OWL MARKETPLACE FILING NO. 1
EL PASO COUNTY, COLORADO
PRE-SUBDIVISION CIVIL CONSTRUCTION PLANS

ENGINEERING RECORD DRAWINGS
KATE VARNUM, P.E.
5/15/2026

COVER SHEET

C8

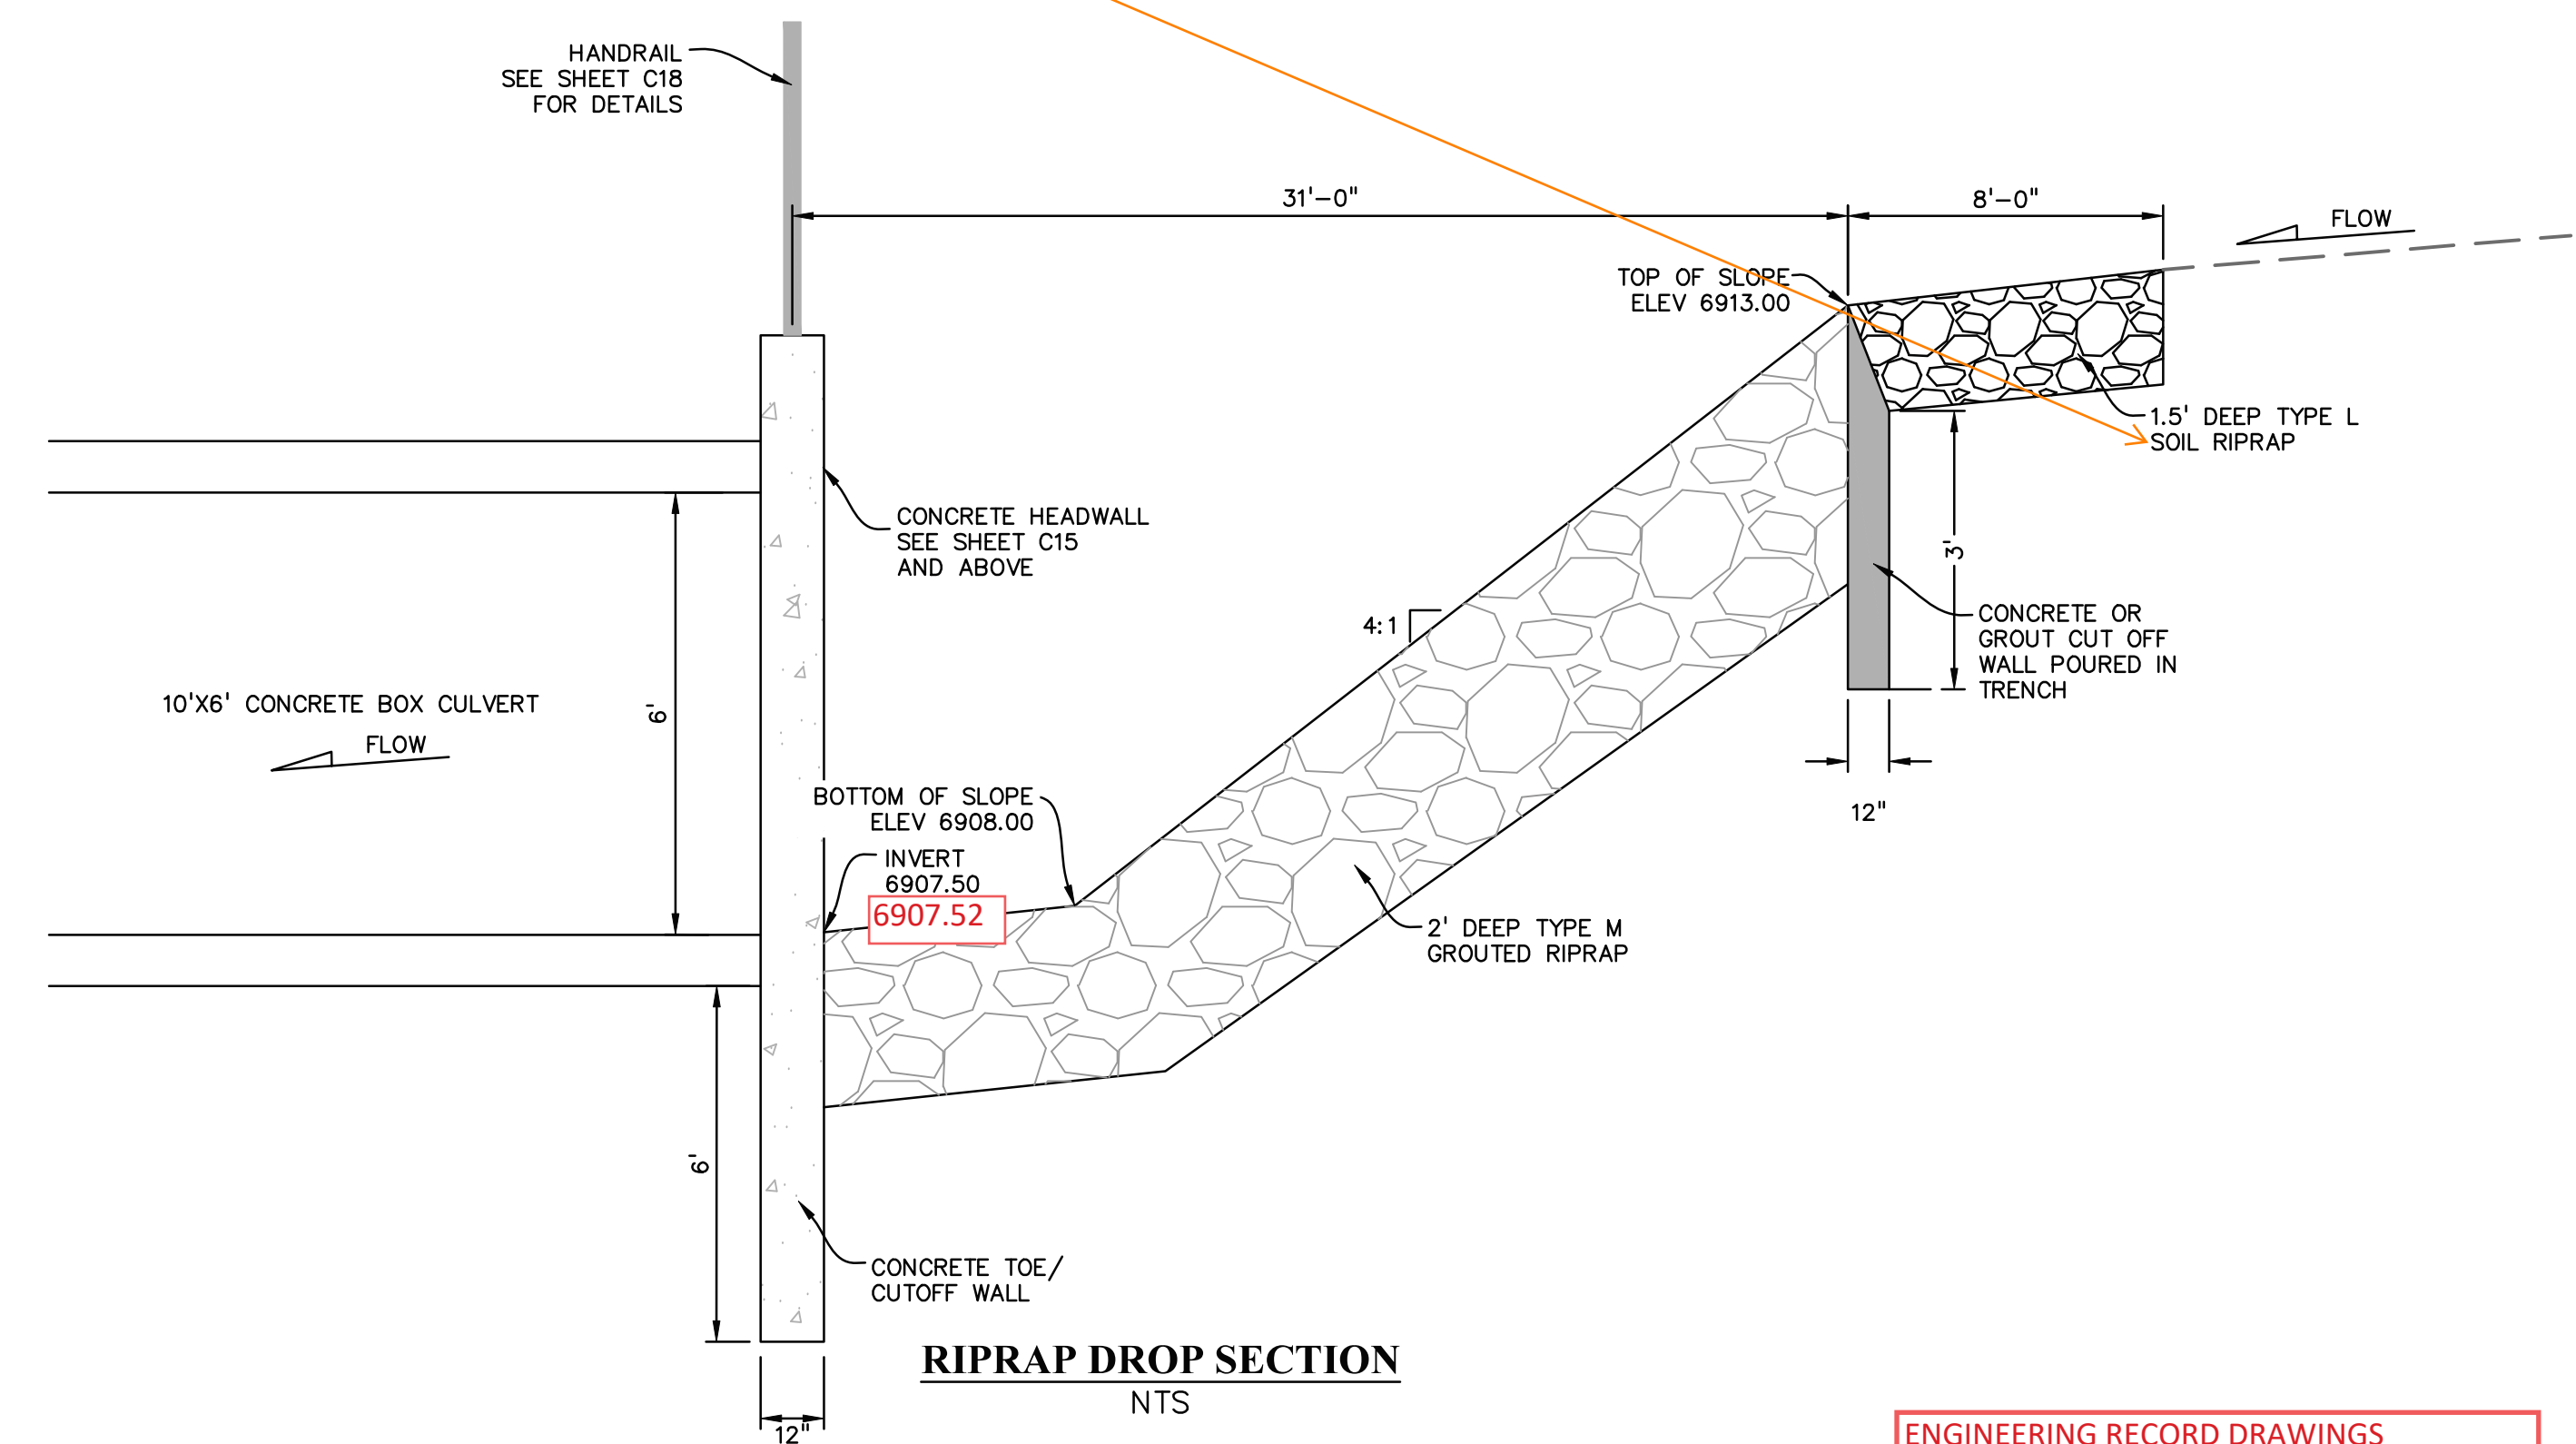
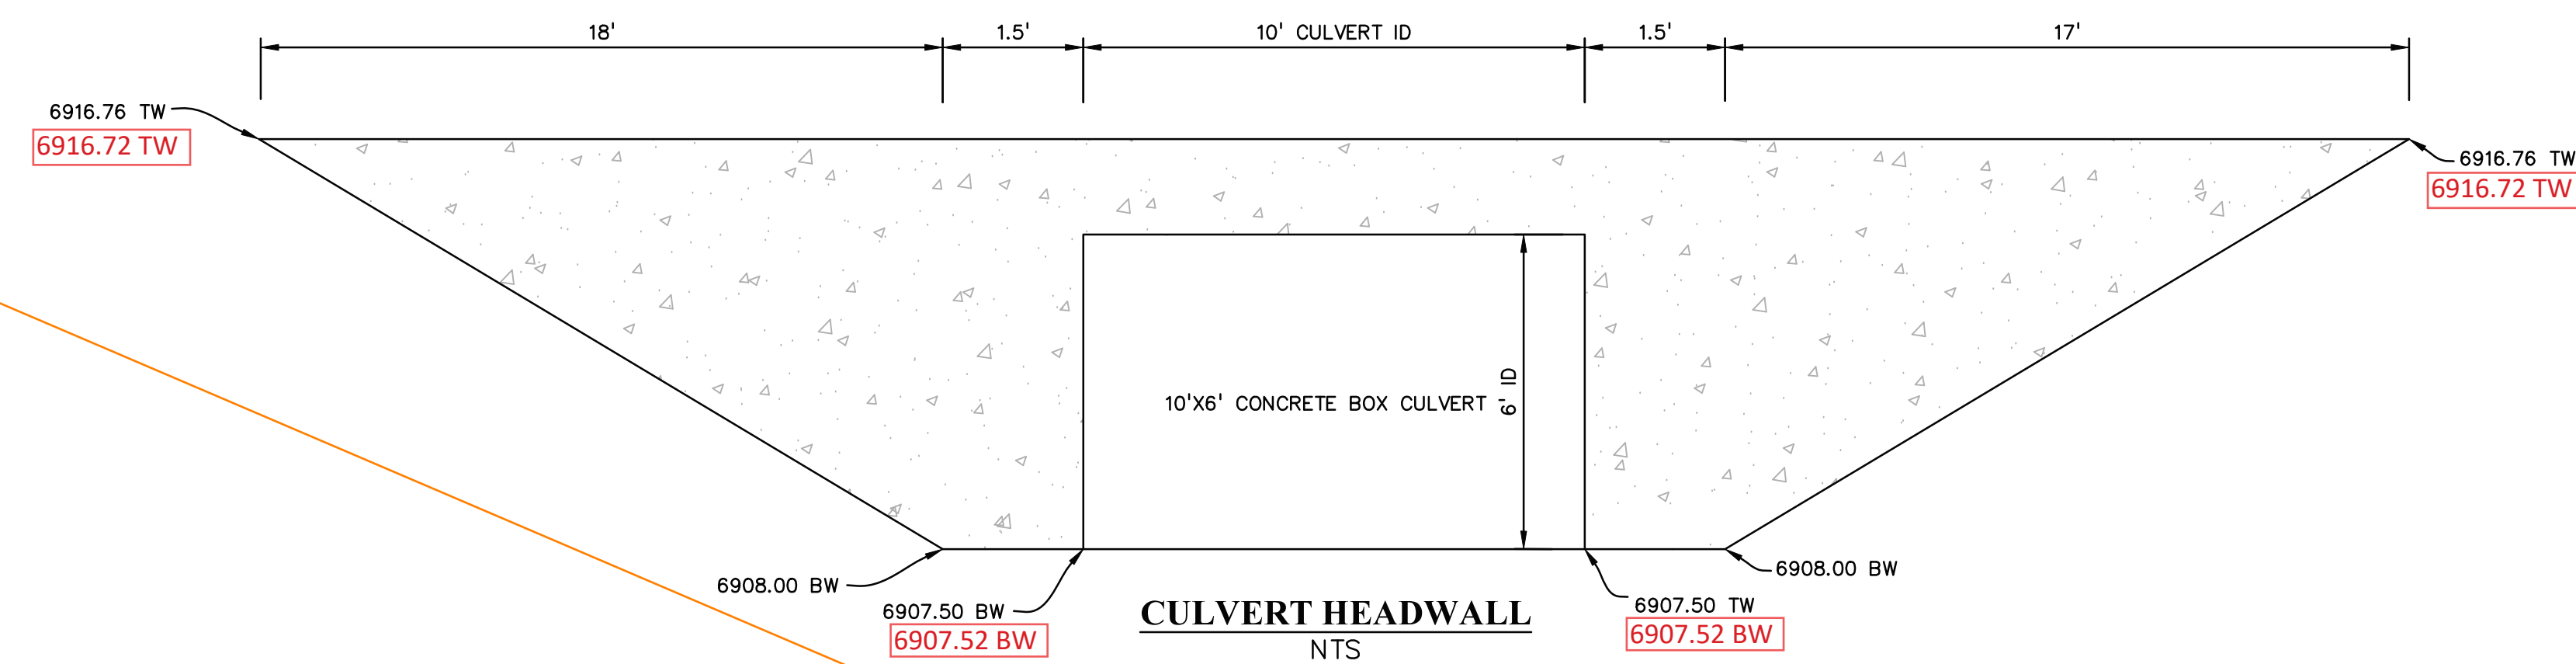
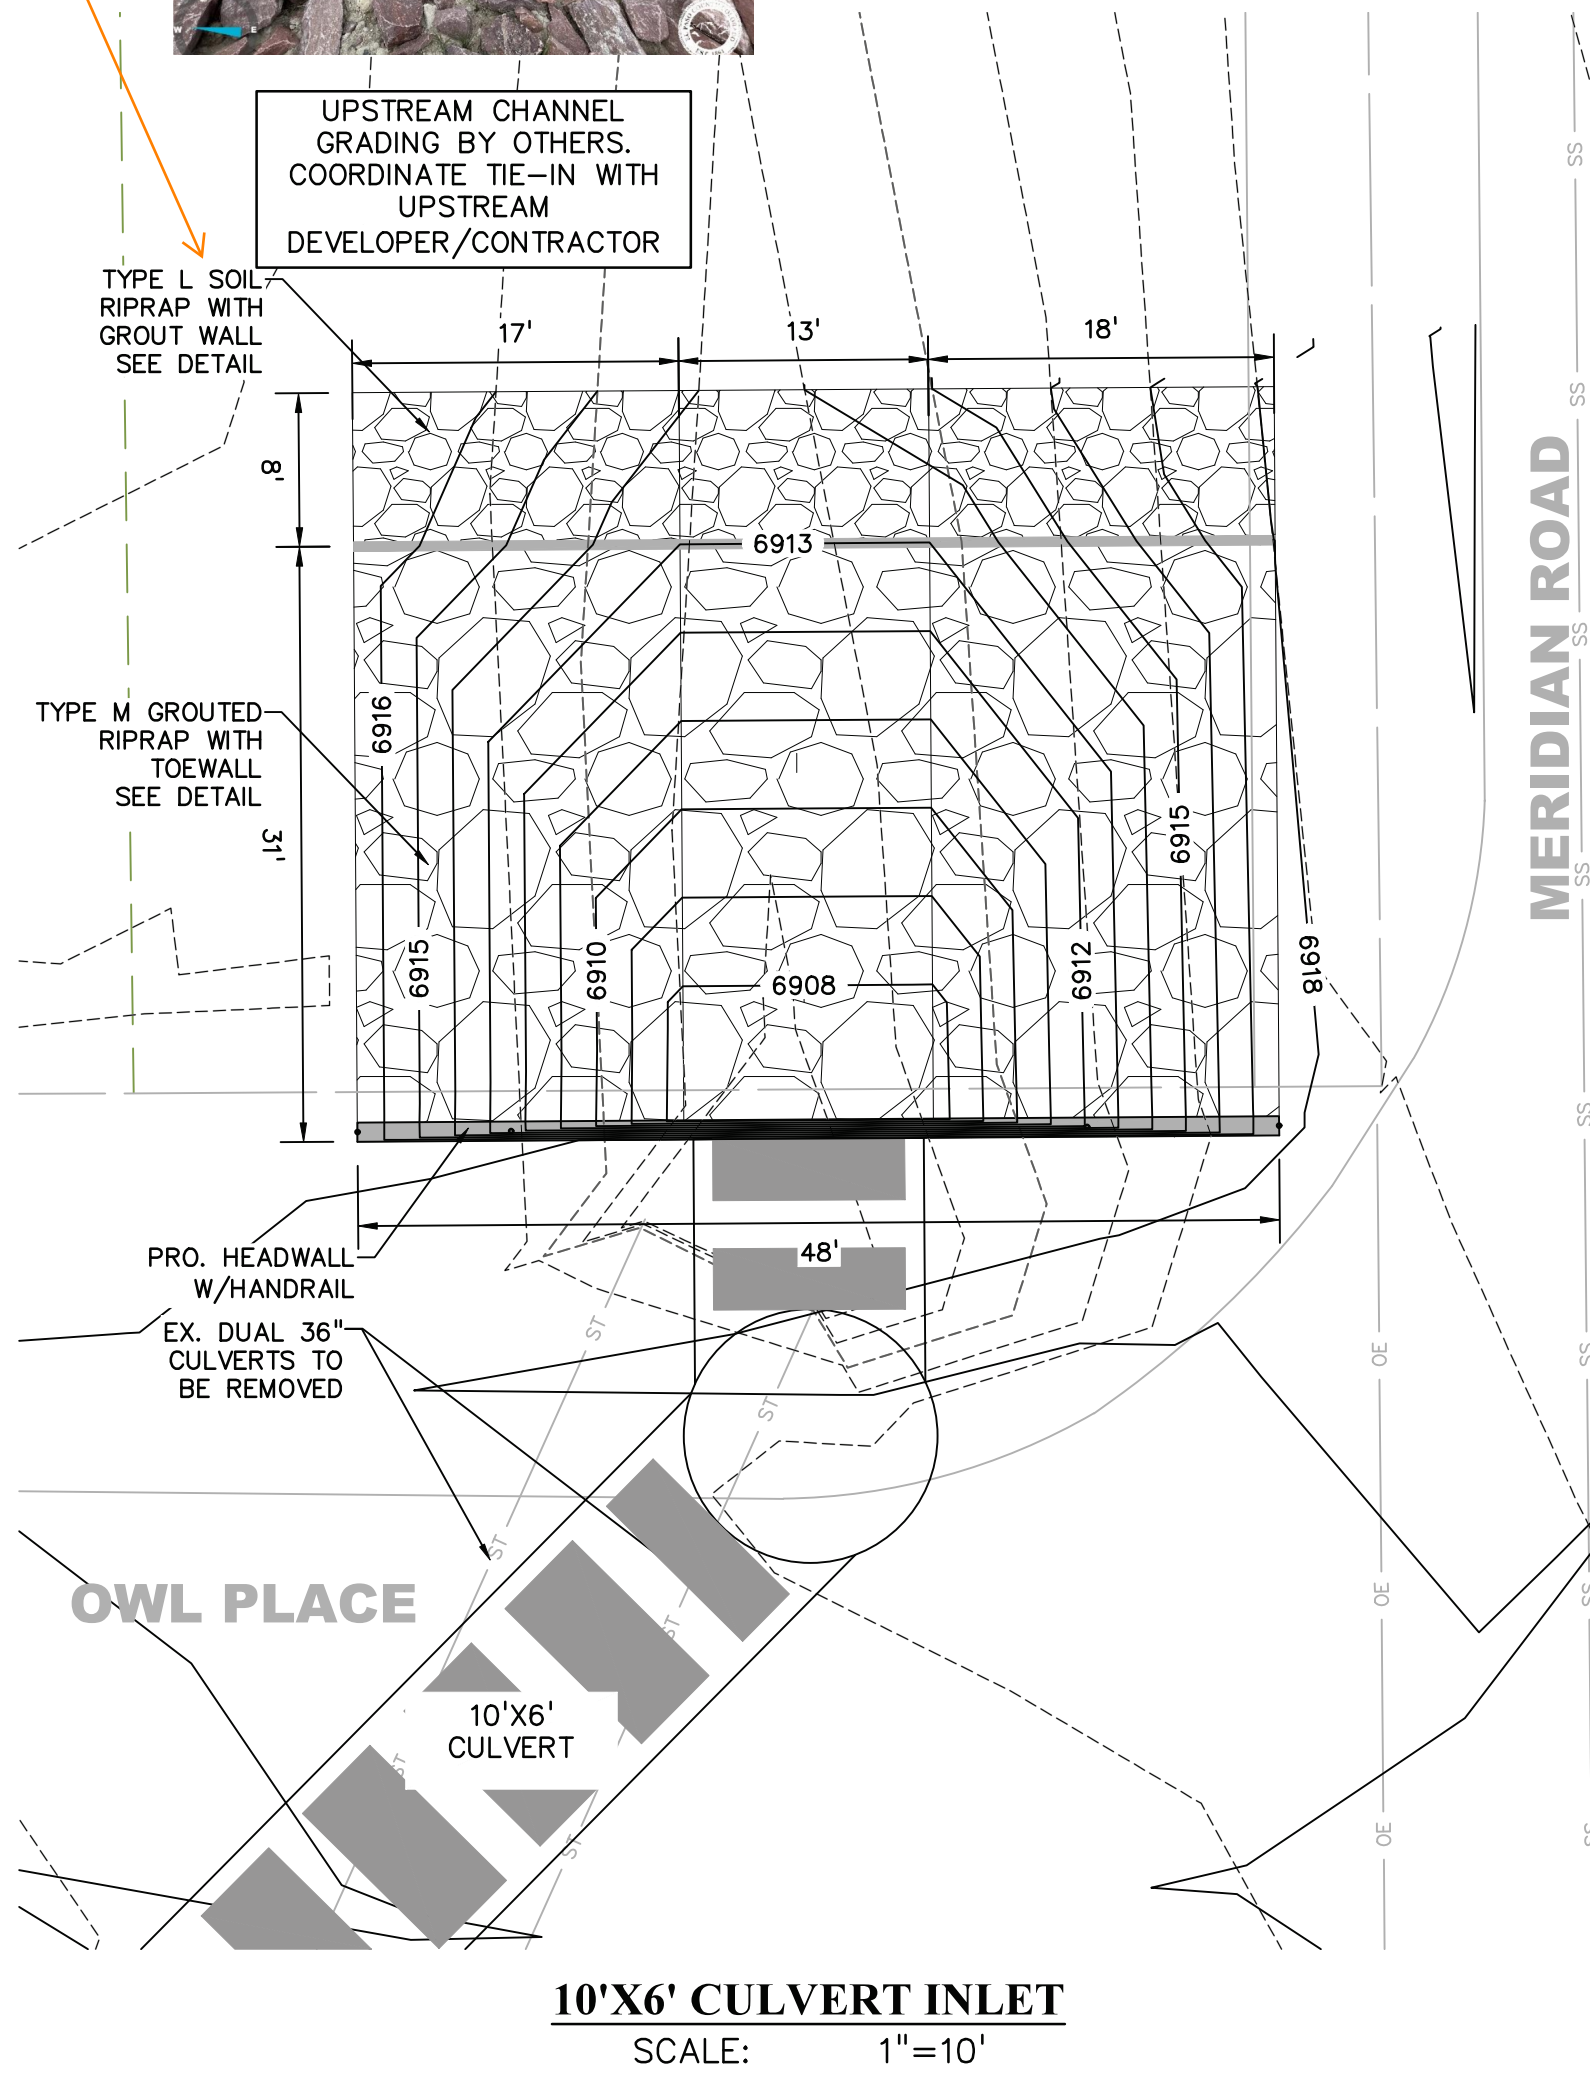
As of our PA walk in April, this was installed as plain riprap, not soil riprap. Please check with the contractor/developer and then as-built this accordingly (with calcs to show that plain riprap works) or install per plans in the field. April photo provided below for reference:
